Access Compliance Report

Public Rights-of-Way

Intersection ID: 27333	Main Street: BALLANTYNE_MEDICAL_PL	Cross Street: BRIXHAM_HILL_AV	Location: NW
ADA ID: 3F88C7A5CAC5	Ramp Type: Perp	Initial Pass/Fail: Fail	Overall Compliance: No
Severity Score: 12.5			
Codes/Mitigation Info/Possible Solution		Field Measurements/Component Compliance

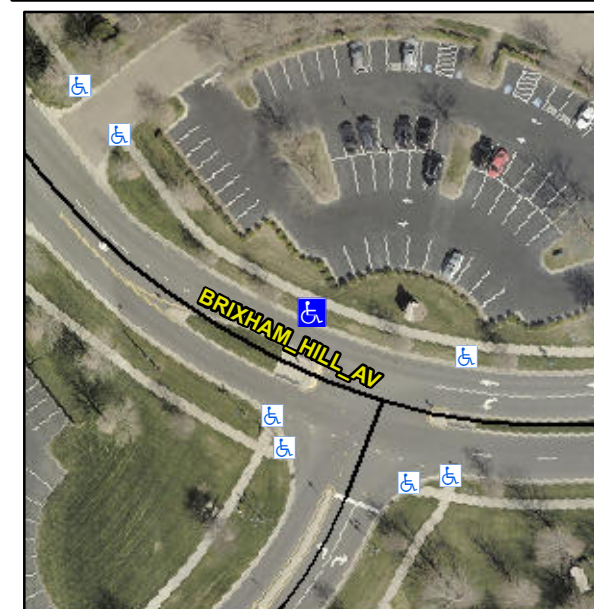
Not Found, R304.2.2

Compliance	Description	Data	Compliance	Description	Data
N/A	Ramp Length (in)	96.0	No	Ramp Slope (%)	10.3
Yes	Ramp Width (in)	57.0	Yes	Ramp XSlope (%)	0.3
N/A	Flare Type LT	N/A	N/A	Flare Type RT	N/A
N/A	Flare Slope LT (%)	N/A	N/A	Flare Slope RT (%)	N/A
N/A	Flare Traversable LT?	N/A	N/A	Flare Traversable RT?	N/A
N/A	Landing Length (in)	N/A	N/A	DWS Provided?	N/A
N/A	Landing Width (in)	N/A	N/A	DWS Contrast?	N/A
N/A	Landing Slope (%)	N/A	N/A	DWS Length (in)	N/A
N/A	Landing X Slope (%)	N/A	N/A	DWS Full Width?	N/A
N/A	Landing Curb? (Y/N)	N/A	N/A	DWS Offset (in)	N/A
N/A	Shared Landing?	N/A			
N/A	Gutter Ponding?	N/A	N/A	Gutter Slope (%)	N/A
N/A	Gutter Lip Ht (in)	N/A	N/A	Gutter X Slope (%)	N/A
N/A	Painted X Walk1?	No	N/A	Painted X Walk2?	N/A
	X Walk 1 Direction	To S		X Walk 2 Direction	N/A
N/A	X Walk 1 Width (in)	N/A	N/A	X Walk 2 Width (in)	N/A
	X Walk 1 Slope (%)	2.0		X Walk 2 Slope (%)	N/A
	X Walk 1 X Slope (%)	0.4		X Walk 2 X Slope (%)	N/A

Remove & Replace Entire Ramp.
